UNITED STATES  
NUCLEAR REGULATORY COMMISSION  
WASHINGTON, D. C. 20555

SAFETY EVALUATION BY THE OFFICE OF NUCLEAR REACTOR REGULATION  
SUPPORTING AMENDMENT NO. 44 TO FACILITY OPERATING LICENSE NO. DPR-63  
NIAGARA MOHAWK POWER CORPORATION  
NINE MILE POINT NUCLEAR STATION, UNIT NO. 1  
DOCKET NO. 50-220

FIGURE 1

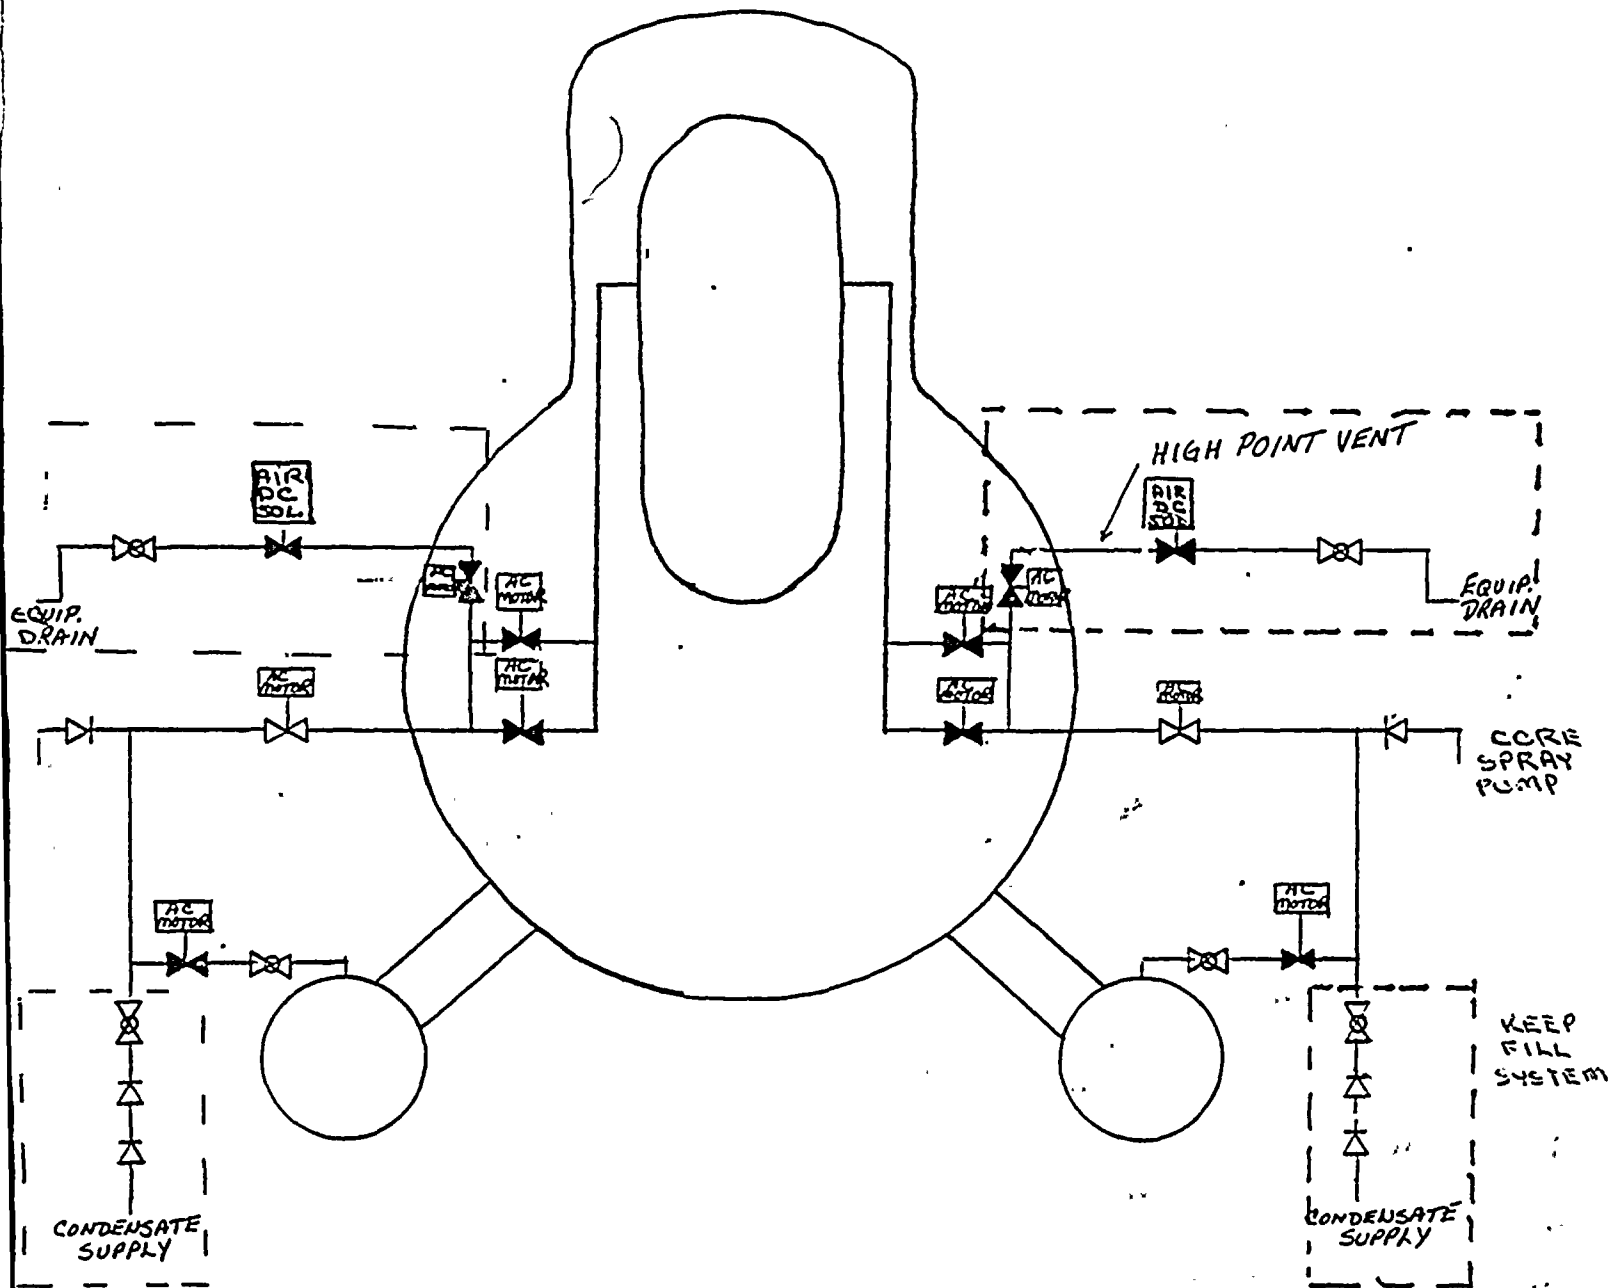
By letter dated March 2, 1981, Niagara Mohawk Power Corporation (licensee) proposed changes to the Technical Specifications to modify the Core Spray System. The Nine Mile Point Core Spray/High Point Vent System is shown on the attached figure. The proposed modifications are shown by the dashed lines.

The keep-fill system uses water from the condensate supply to maintain a water inventory in the core spray piping. The stop check valves and downstream piping were designed to ASME Section III, Safety Class 2. The pressure rating of the check valves is equivalent to system pressure (1200 psig). The keep-fill system will be beneficial in that it will provide a constant head on the core spray pump discharge check valve thus preventing movement of its disk.

The high point vent system will also be designed to ASME Section III, Safety Class 2. Both the inside motor operated valve and the outside air operated valve are normally closed and receive automatic isolation signals upon low-low reactor water level or high drywell pressure. Both valves will be subject to local leak rate testing per Appendix J to 10 CFR Part 50 and periodic exercising per ASME Section XI.

The licensee has agreed to Technical Specifications to periodically (at least monthly) open the high point vent valves and verify that the keep-fill system is maintaining the piping volume full of water. This will provide additional assurance that the operability of the core spray system will not be degraded due to water hammer. The licensee has also implemented Technical Specifications governing Reactor Coolant System Isolation Valves. (Reference 2).

The addition of the keep-fill system and the high point vent should prevent water hammer and permit ASME Section XI testing without shutting the facility down. We have reviewed the design criteria of the systems and find them acceptable. Based upon our review of the licensee's submittal we find both the proposed modifications and the associated revision to the Technical Specifications to be acceptable.
